Addendum No.: 3

Date of Addendum: June 2, 2020

Willard Diloreto Parking Garage
Paul Manafort Sr. Drive
New Britain, CT
CF – RC – 402

The following clarifications are applicable to drawings and specifications for the project referenced above.

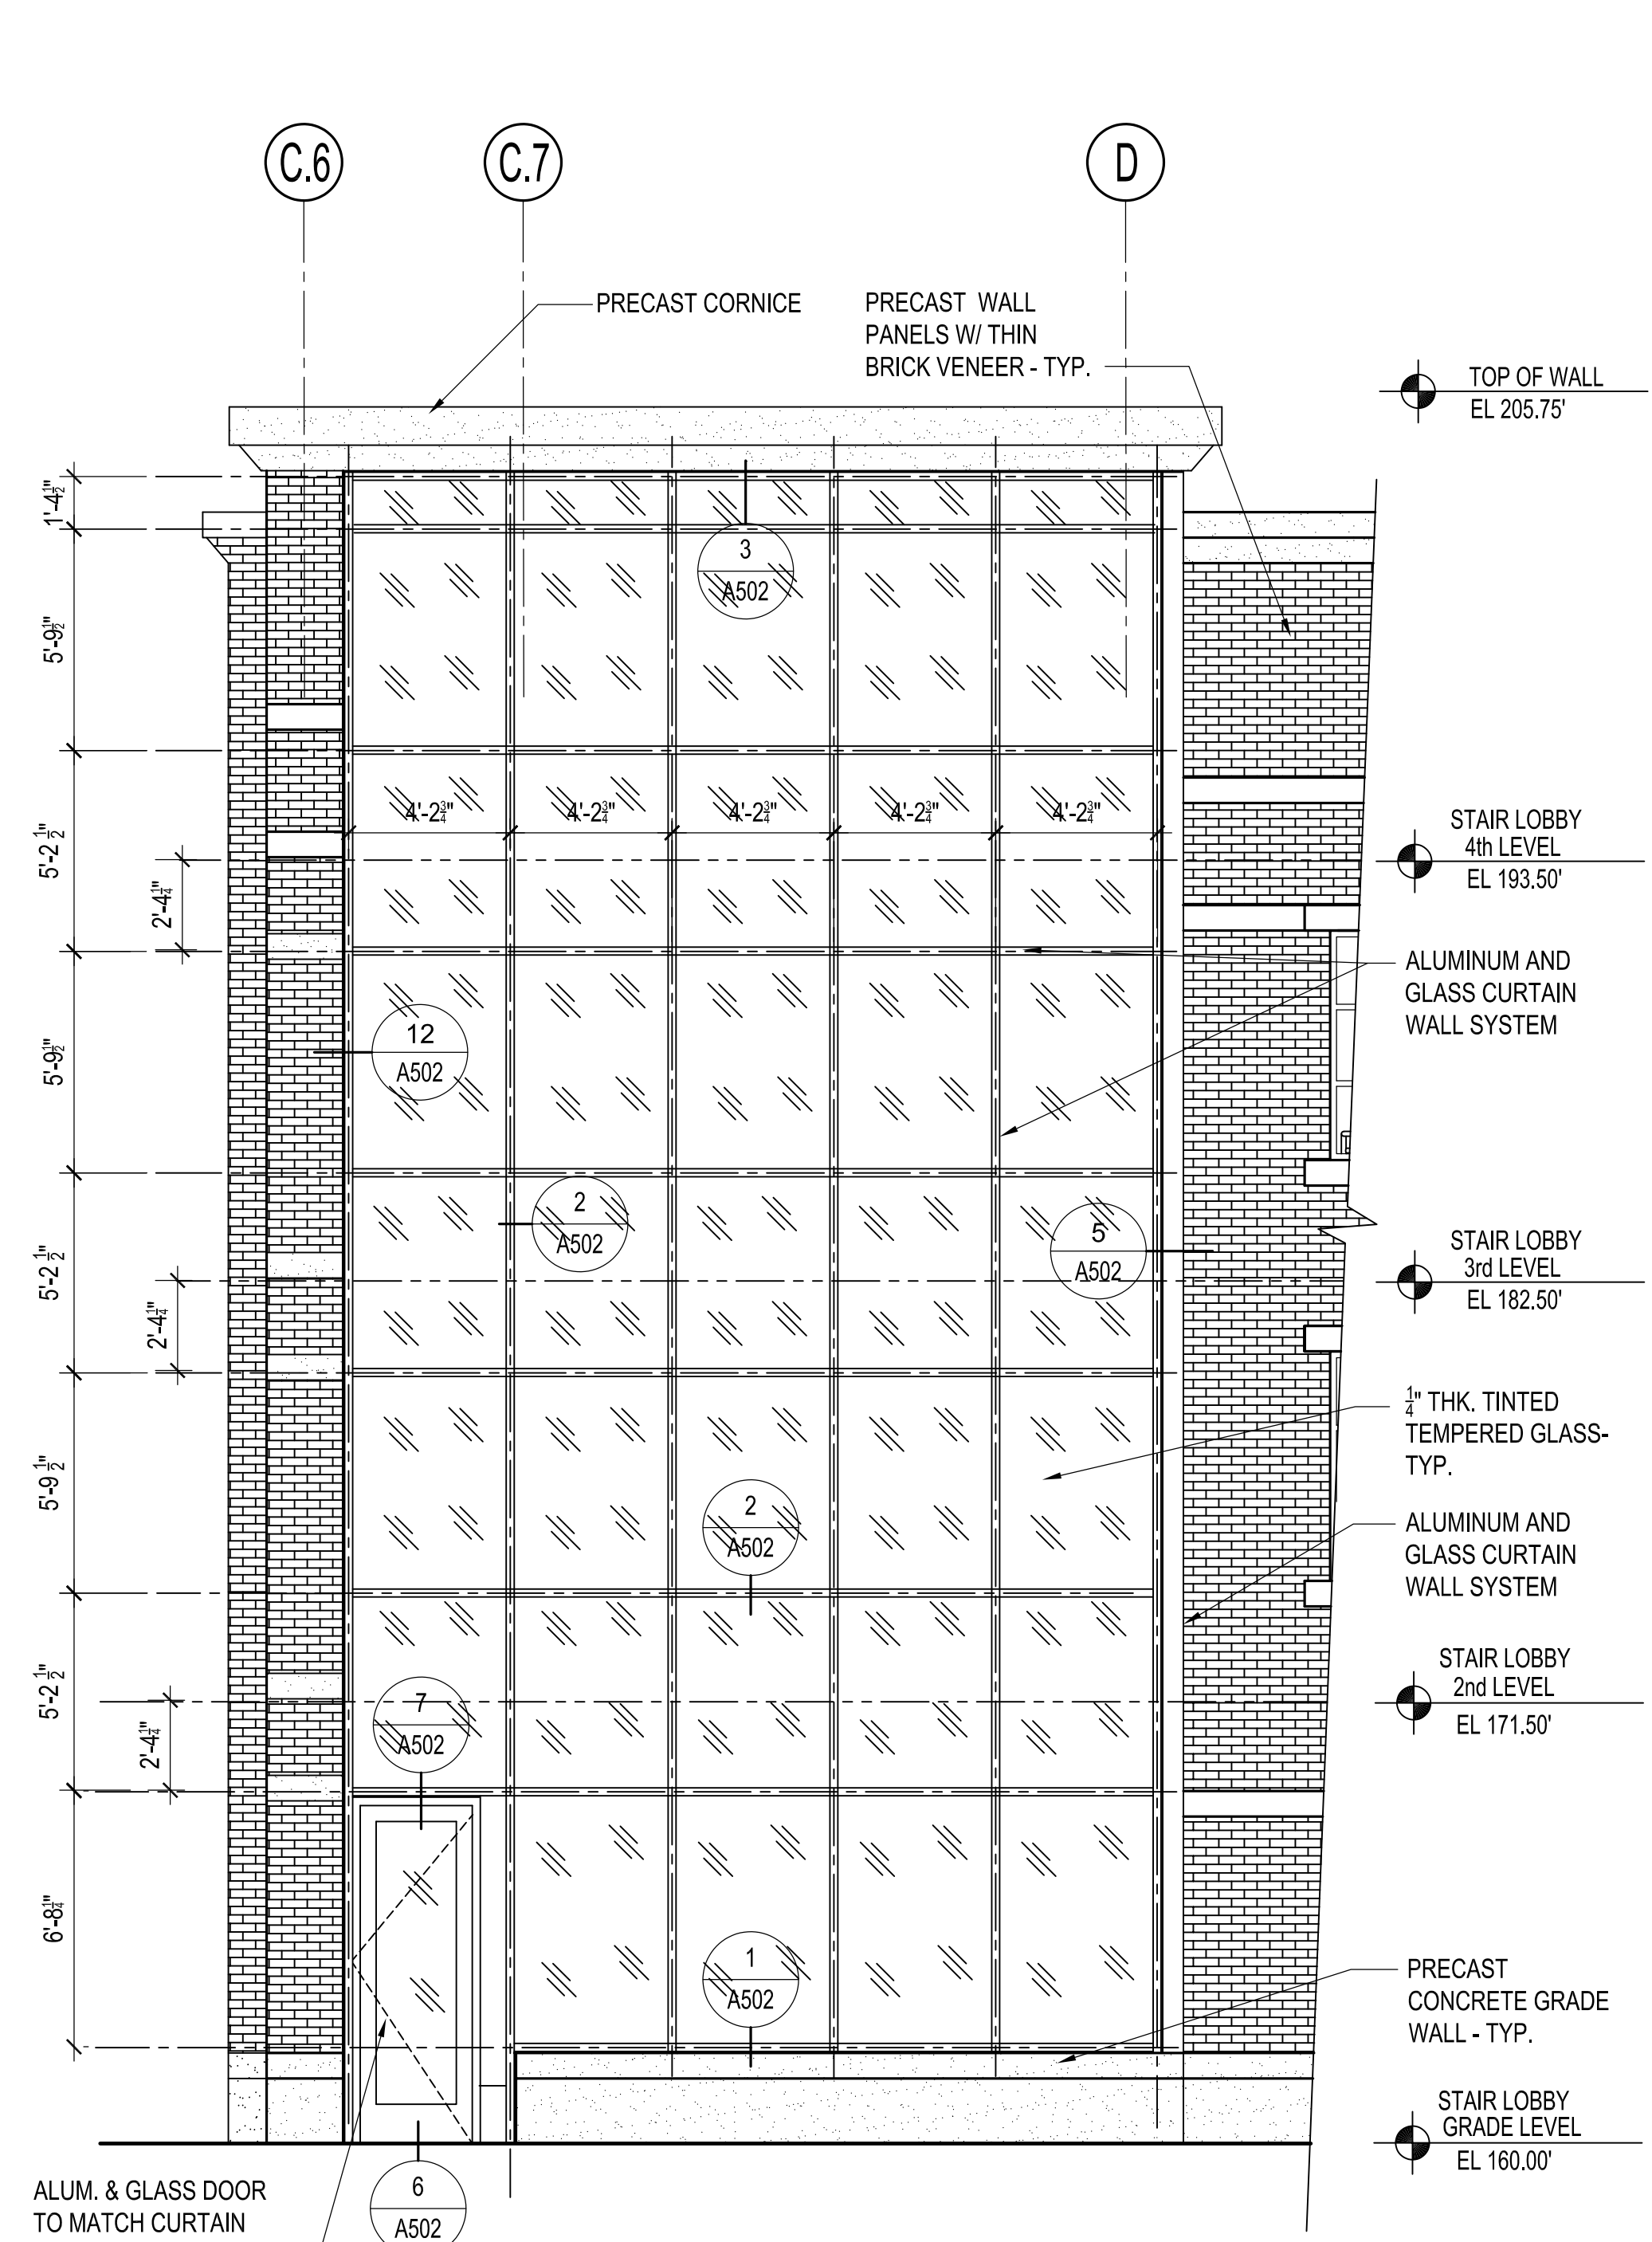
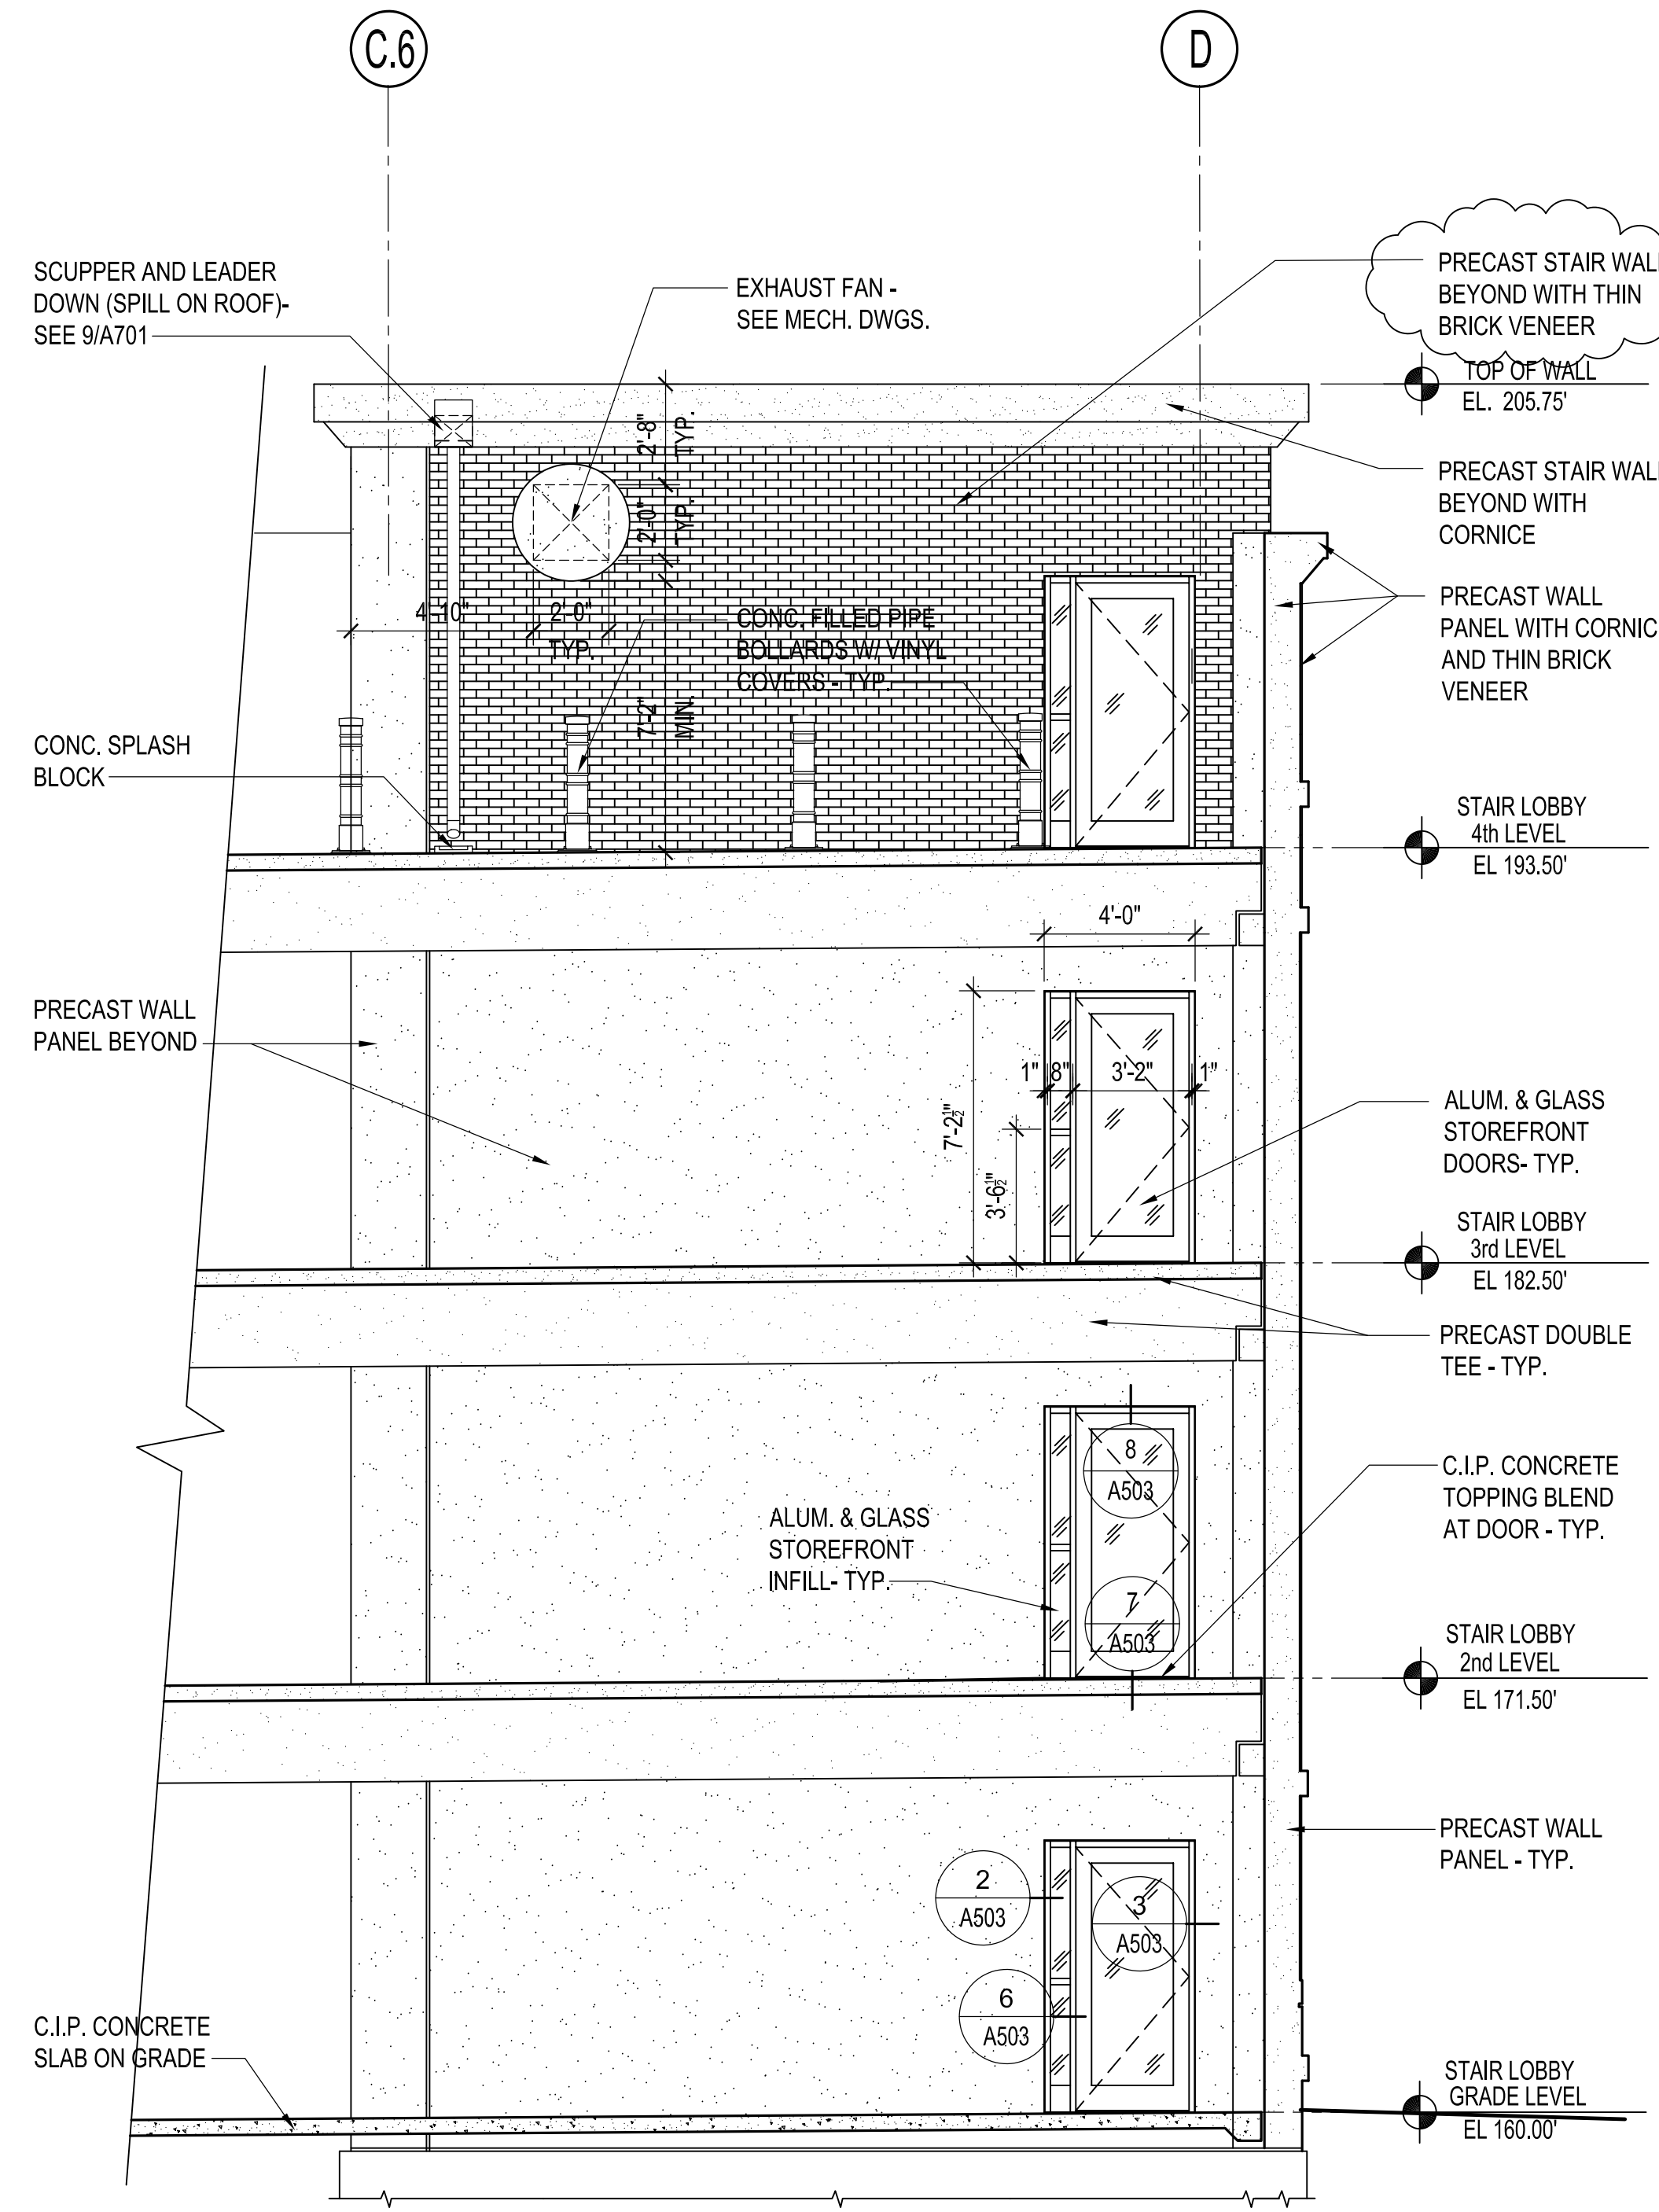
Question: Layout and Elevation Drawings- We do not find any drawings or details that clearly define the edge/end finish of the wall panels with the built-in-pilasters located along the North & South Elevations of the garage. The Elevations show a 'thin brick' finish on the exterior face of the wall panels, but the return portion (edge of panel with built-in-pilaster) is not clearly defined. Detail cuts '2', '3', & '4', from drawing A203, and Wall Section 2 on drawing A601, do not indicate a requirement for thin brick on return portion of the precast wall panels. Please provide a detail showing the finish for the return portion (edge/end of panel with built in-pilaster).

Answer: See revised drawings A203, A402, A407, A409, A601 and A602 showing extents of thin brick and thin brick returns at openings.
